Technical Note:

Hendy Quarry Inert Landfill Permit Variation (PAN-003267): Schedule 5 response

March 2019

62847TN4

Figure 4.1 Cross section B-B' (Caulmert, 2018)

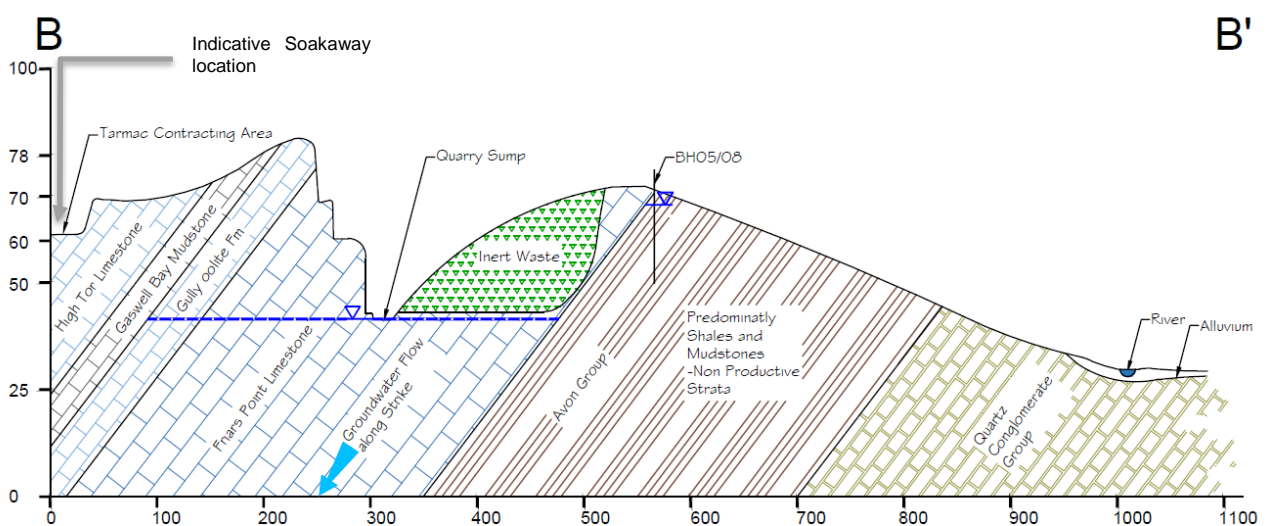
ACTION: Please provide further information on the geology and hydrogeology of the soakaway location, including the thickness of the unsaturated zone at the discharge point. Also, please confirm if the discharge is a direct or indirect discharge to groundwater.

With reference to Figure 4.1, taken from the HRAR (Caulmert, 2018), the soakaway is located approximately north of the 'Tarmac contracting Area' (extreme left on the cross section). The section shows the inferred geology below the soakaway location and its location relevant to the sump.
